April 29, 1994
LD-94-032

Docket No. 52-002

Subject: Response to Comments on Design Certification Material

CE 80 + ITAAC Independent Review Comments

FIGURE 2.5.1-2
PLANT PROTECTION SYSTEM INTERCONNECTIONS

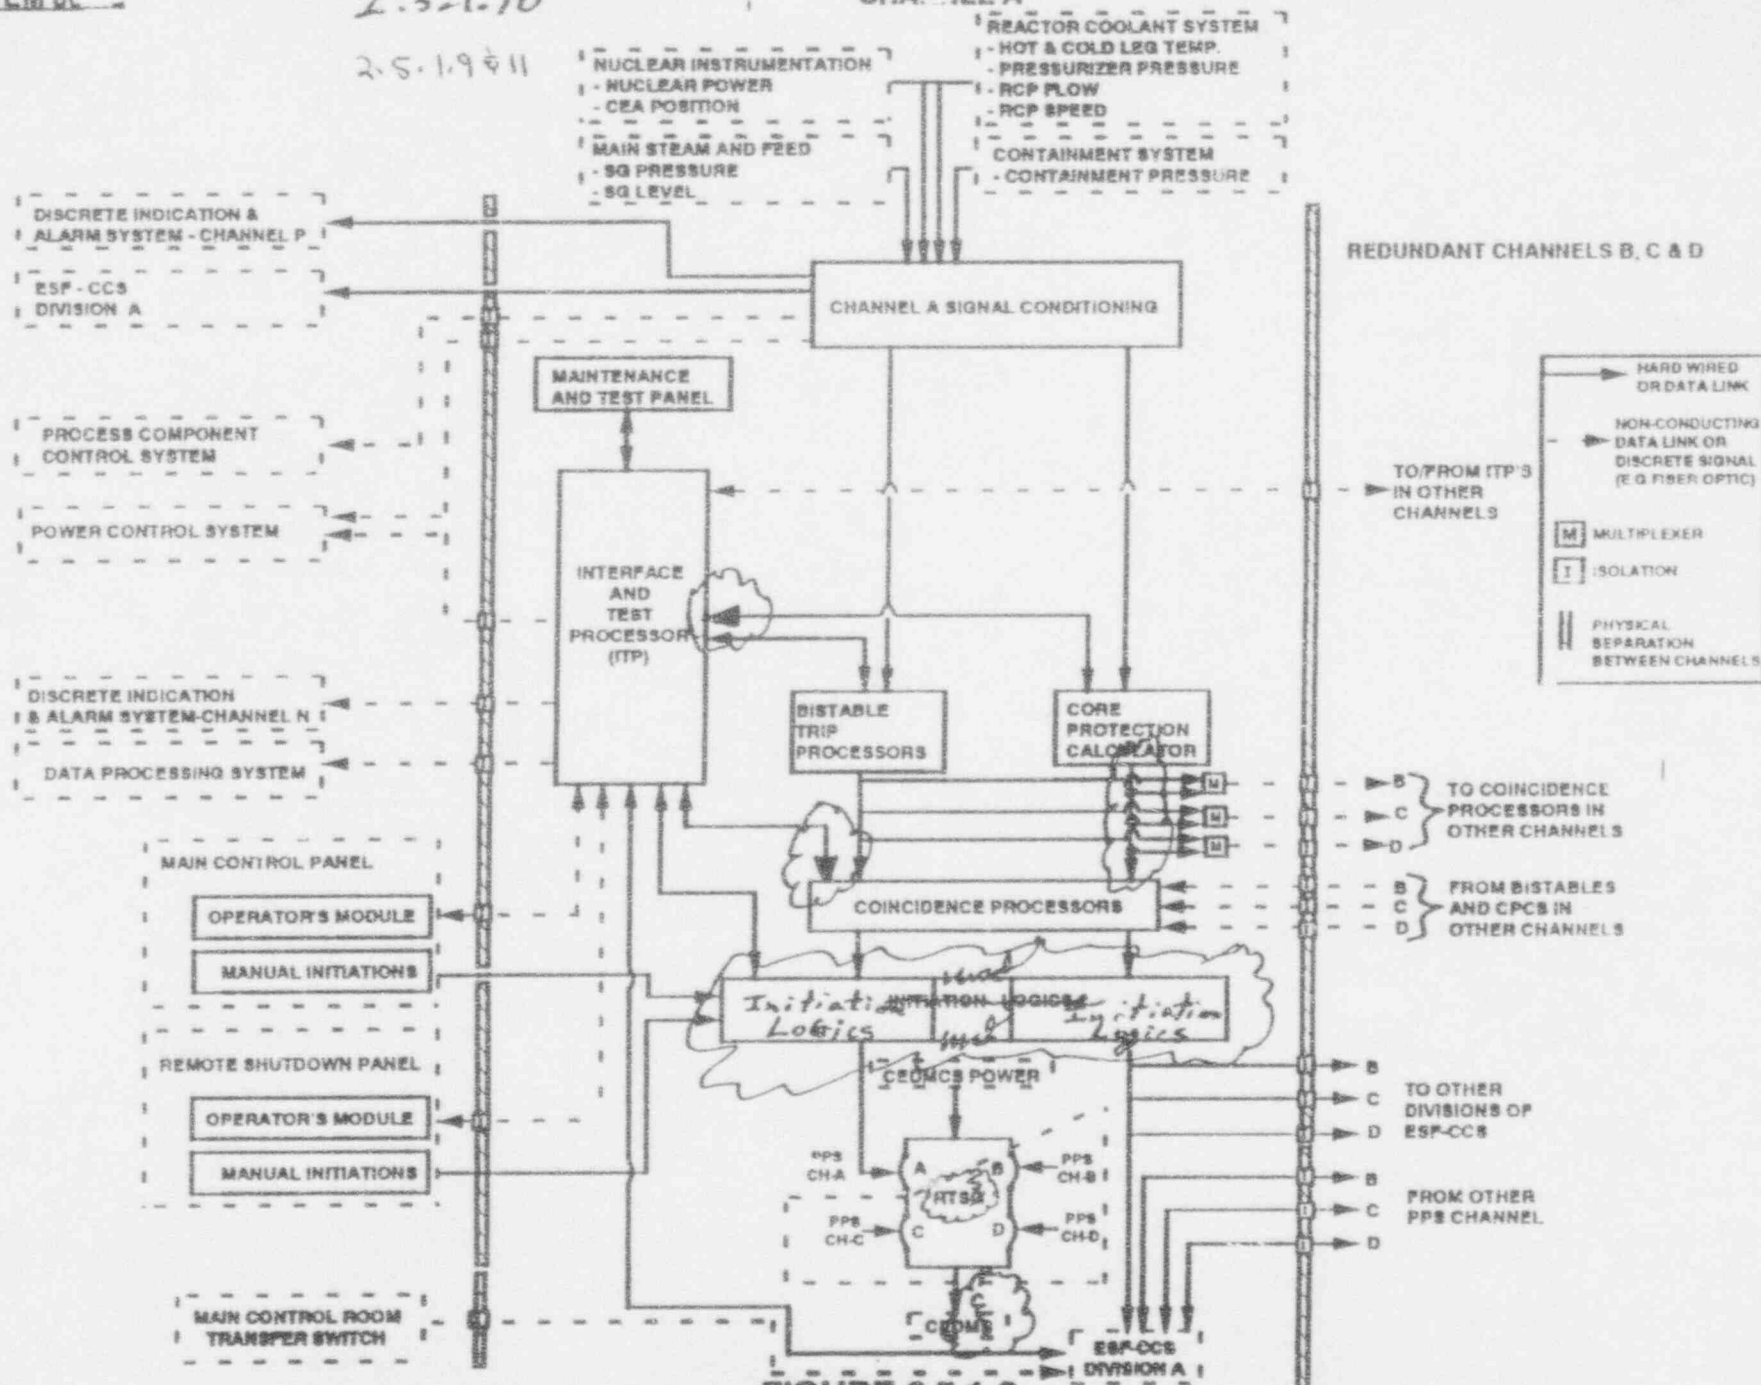
No.	Comments	Cat.	Resolution
1	Figure 2.5.1-2, "PPS Interconnection" does not clearly specify 2 coincidence/bistable processors per channel. See 2.5.1, Pg 1 (attached)	1	The ITAAC figures and Design Description are intended to specify the Tier 1 design. This has meant limiting the level of detail from that given in CESSAR-DC text and figures. In some cases, detail has been provided in the design description text rather than figures and vice versa. It is intended that the sum of the ITAAC text and figures reflect the Tier 1 description of the design in total. This approach was agreed to with the NRC.
2	Page 1 of design description states that the Interface and Test processor communicates with the bistable trip processors and coincidence processors. Figure 2.5.1-2 indicates that the ITP communicates with the Core protection calculator, control room and remote shutdown panels, ESF-CS, maintenance and test panel and the initiation logics. The design description should be clarified. See Figure 2.5.1-2 (attached).	1	Refer to response 1 of N.2.5.1, above.

No.	Comments	Cat.	Resolution
10	<p>Figure 2.5.1-2. The figure indicates that communication between the CPC and the ITP and ITP to coincidence processors is in only one direction. Is this correct? Core protection calculator output is unclear (drafting error). The coincidence processors (Figure 2.5.1-2) indication two output paths. What is the distinction between the two? (it appears that the initiation logic block should be split to represent ESF logic in the figure and be consistent with Figure 2.5.1-3. In Figure 2.5.1-1 the RTSG is shown feeding the CEDMCS. Figure 2.5.1-2 states CEDMS. The design description references the CEDM system (see Page 5, last paragraph)? System notations are not consistent. (see attached).</p>	1	<p>Agree. Communications shown as one way between the ITP and the CPC and coincidence processors on Figure 2.5.1-2 will be revised to show two way communication. The figure will also be revised to correct the drafting error to clarify the CPC output.</p> <p>On this figure, one output path of the Coincidence Processor block represents the RPS trip initiation signal; the other output path represents an ESFAS initiation signal. Figure 2.5.1-2 will be revised to split the Initiation Logics block to represent ESF logic consistently with Figure 2.5.1-3.</p> <p>The term Control Element Drive Mechanism Control System (CEDMCS) will be used and consistency verified between the ITAAC document and CESSAR-DC.</p>

FIGURE 2.7.3 -1
POOL COOLING AND PURIFICATION SYSTEM

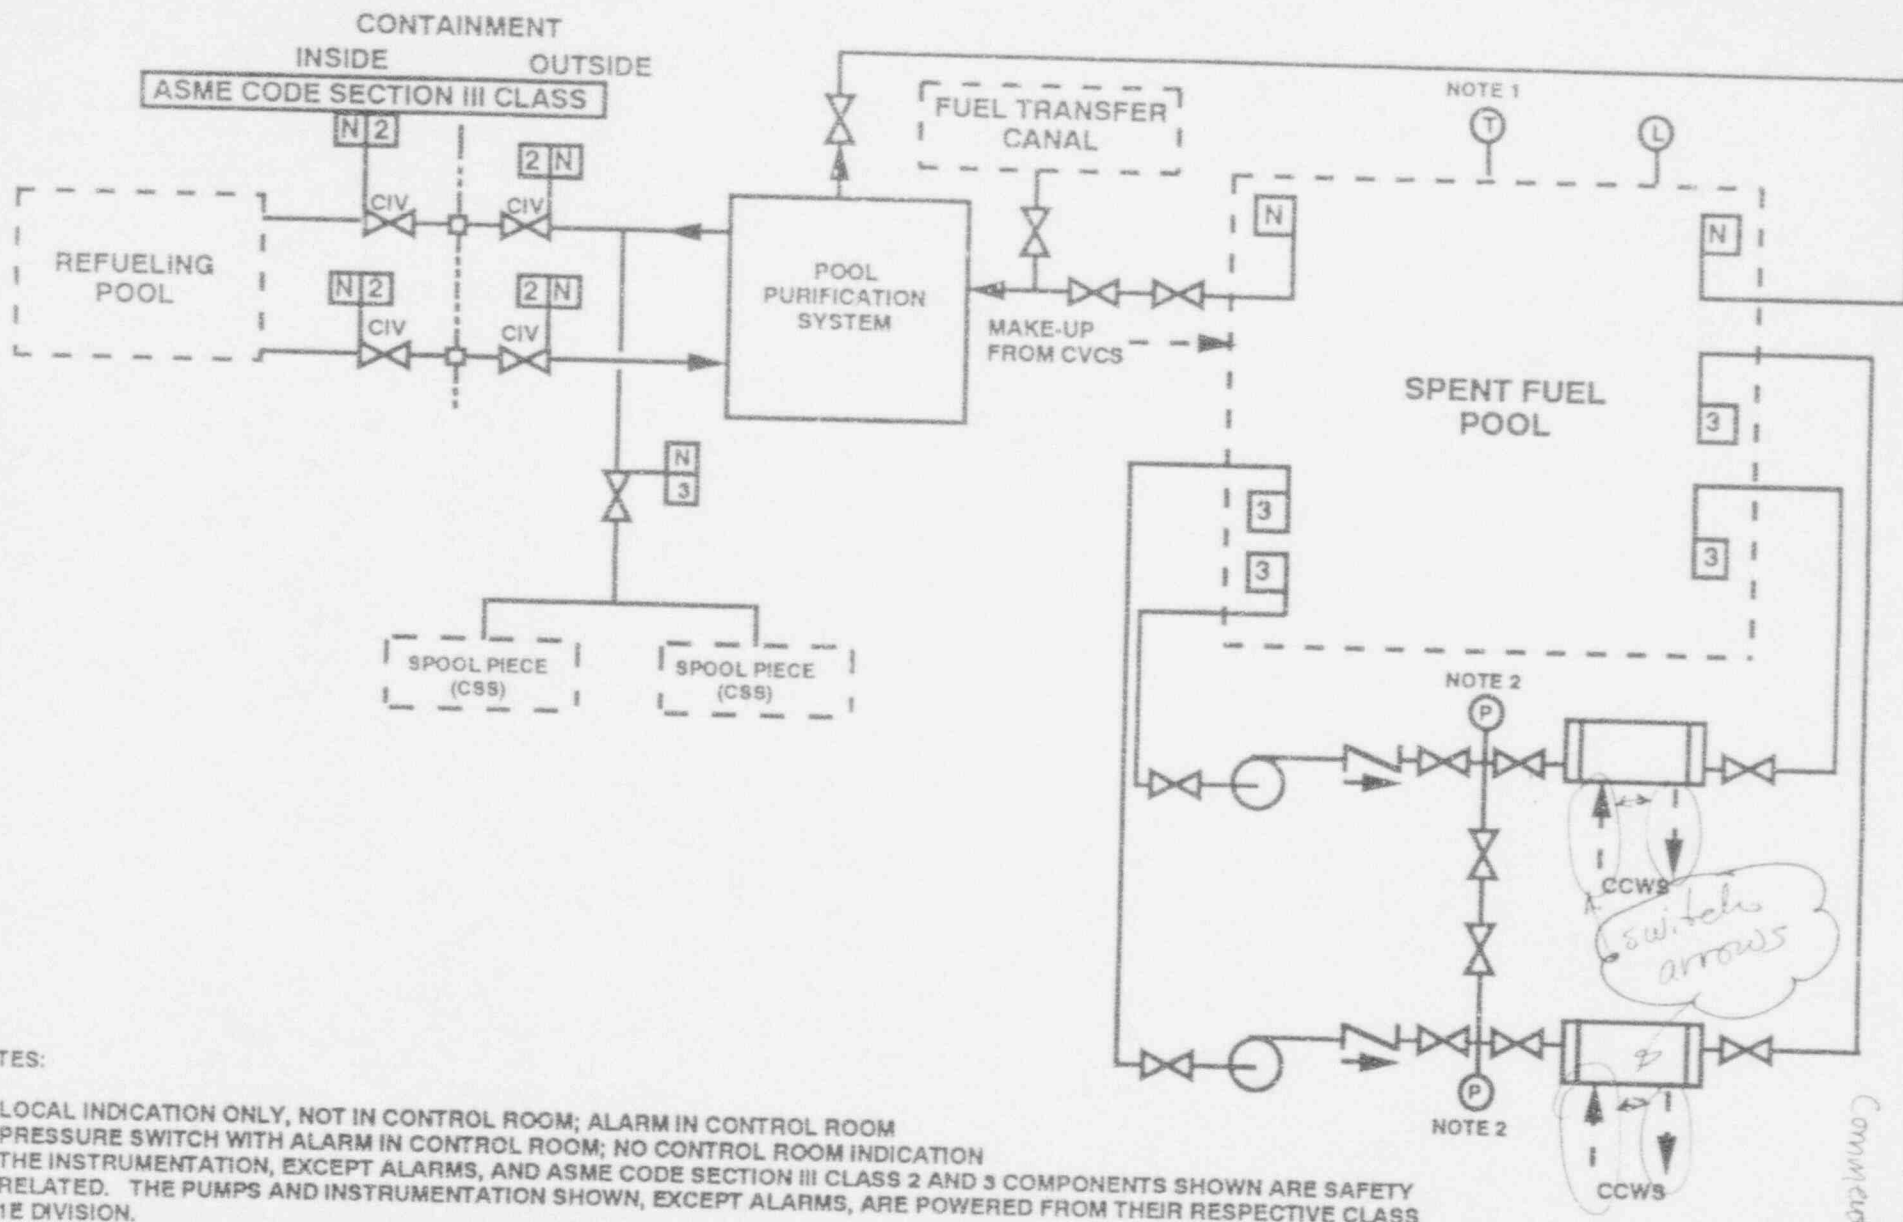
No.	Comments	Cat.	Resolution
1	Figure 2.7.3-1: Reverse the flow directions of the CCWS to the SPF heat exchangers to counter-flow; to be consistent with P&ID 9.1-3 and Figure Legend page 3.	1	ABB-CE agrees. Figure 2.7.3-1 will be revised to show the flow direction of CCWS as counter-flow, as shown on the attached markup. NRC Staff concurs.

FIGURE 2.7.8-1
CONDENSATE STORAGE SYSTEM

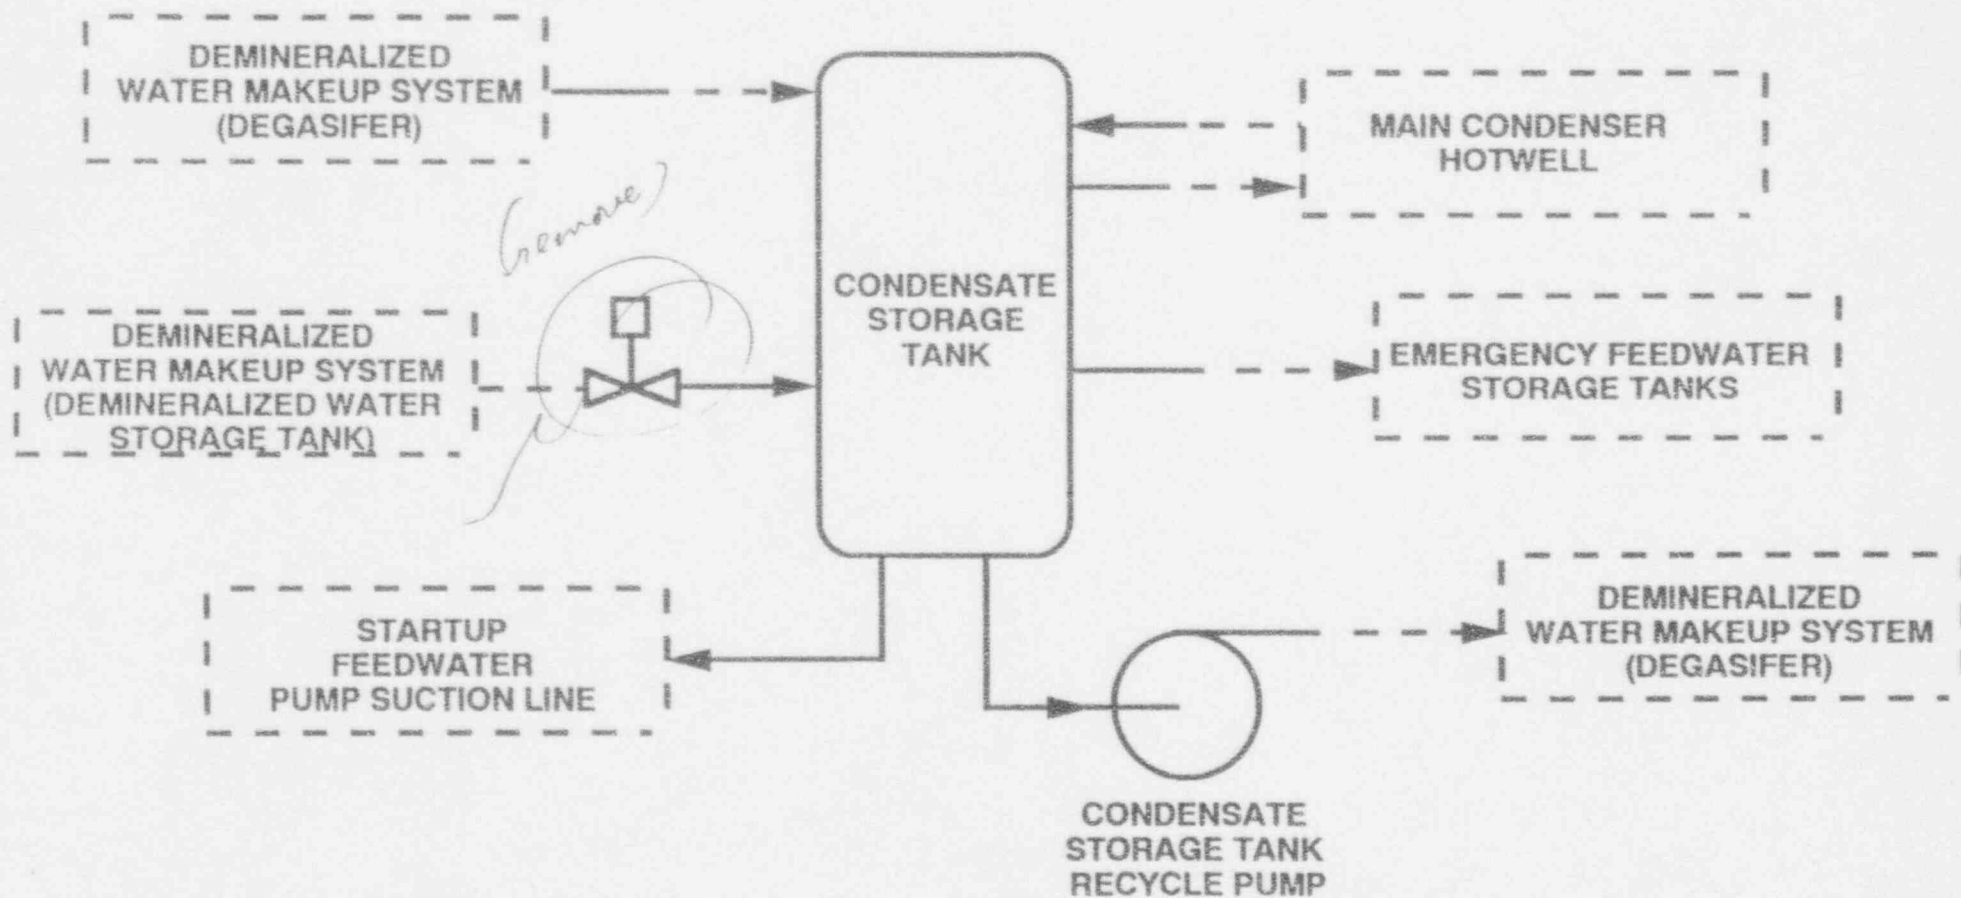
No.	Comments	Cat.	Resolution
1	Figure 2 7.8-1 showed a gate valve with an unspecified operator. CESSAR Figure 9.2.6-1 showed a diaphragm operated globe valve controlling the tank level from signals generated by a level transmitter. Please resolve this discrepancy.	1	Agree. The gate valve will be removed from Figure 2.7.8-1. Inclusion of this valve is not consistent with the level of detail for this non-safety system.

FIGURE 2.7.11-1
TURBINE BUILDING COOLING WATER SYSTEM

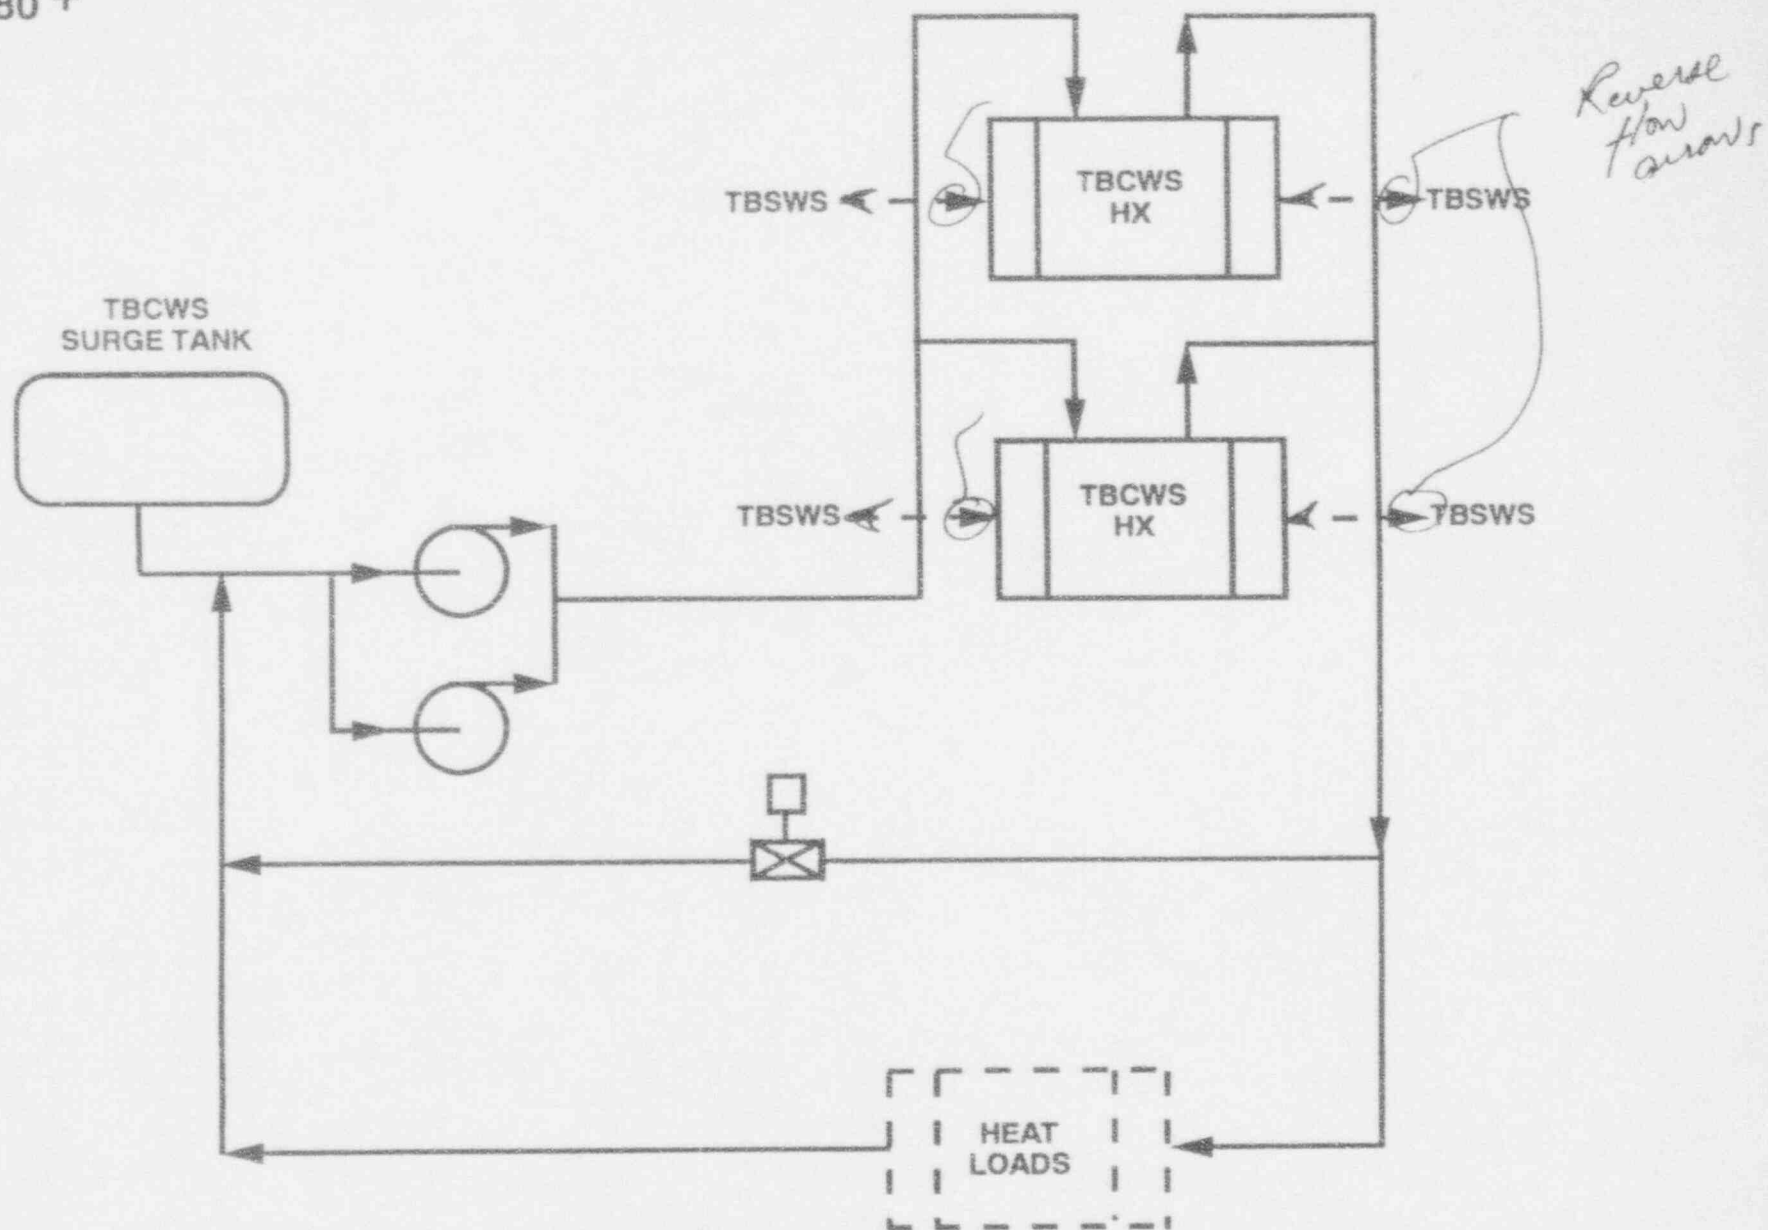
No.	Comments	Cat.	Resolution
1	On Figure 2.7.11-1, show the TBCWS HX as counter-flow type to be consistent with the HX legend of page 1.3-3.	1	Agree. See markup.

FIGURE 2.7.13-1
NORMAL CHILLED WATER SYSTEM
(ONE OF TWO DIVISIONS)

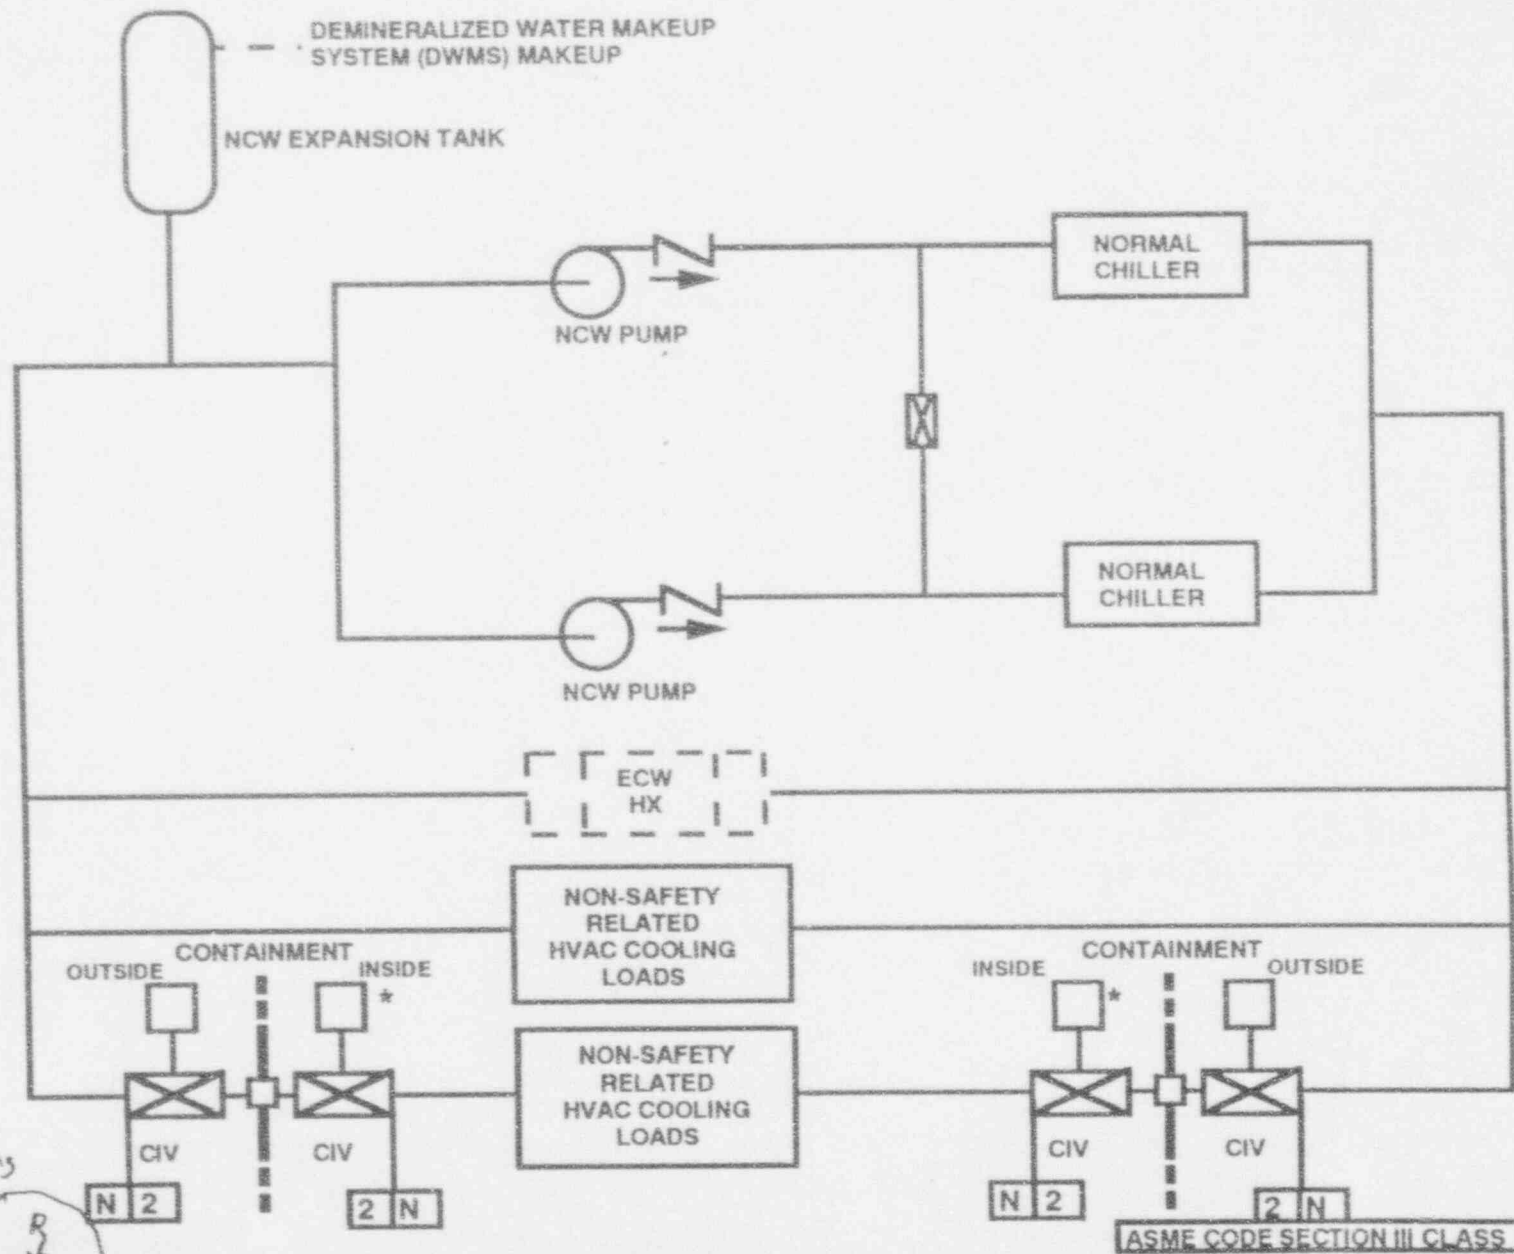
No.	Comments	Cat.	Resolution
1	See attached markup.	3	Agree. See markup of ITAAC Figure 2.7.13-1.
